6672A-10

S E R V I C E N O T E

**6672A - DC POWER SUPPLY, 0-20 V, 0-100 A, 2000 W.
GPIB CONTROLLED**

Serial Numbers: MY41000101/ MY41001194 SG41000101/ SG41000257

Situation:

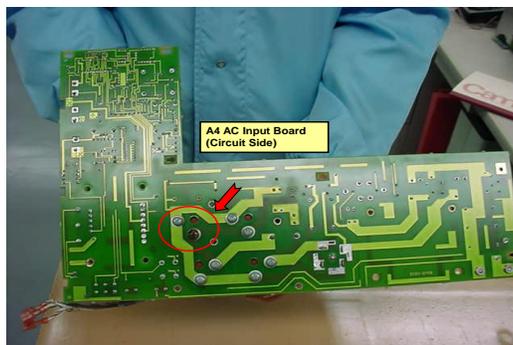
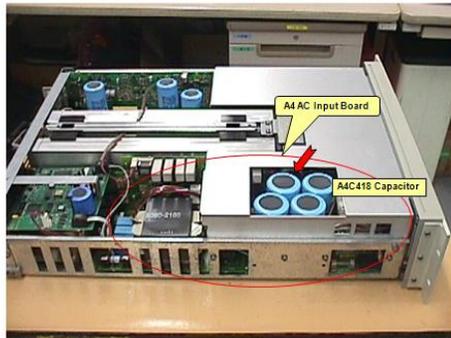
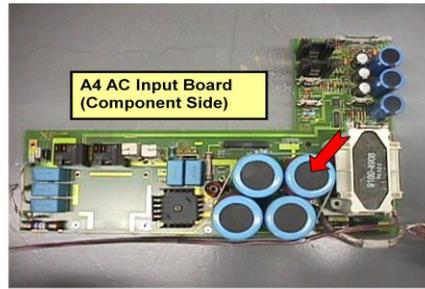
The four filter capacitors circuit reference (C416-C419) on the A4 AC input board starts leaking electrolyte - not through the pressure valve in the bottom as one would expect but through one of the terminal screw bushings.”

The screw P/N 2680-0217 length currently being used was not considered and the length was overlooked. The screw length is 0.375 inches long. We have found that the screw can be 0.055 inches too long and may bottom out causing the tapped hole in the header of the capacitor to become cracked or become broken.

When this happens the electrolyte will slowly leak out over time, and cause the defect described. This situation is even worse due to the capacitor is mounted with the header face down. If the capacitor was mounted header face up a cracked or broken header would not have caused this problem, the electrolyte could not leak out.

1. All affected models and tested assemblies WIP (Work In Process), FGI (Finished Goods Inventory) at SPO (Support Parts Organization) & AMC (Asian Manufacturing Center) has been inspected for capacitors with damaged headers due to the incorrect screw
2. When this repair is being done all of the hardware described above should be replaced (It is NOT recommended that any of the hardware be reused)
3. The following figures can be used when doing the repair.
4. Inspect the assembly as described below.
5. The last figure will aid in the reassembly of the hardware and the capacitors.
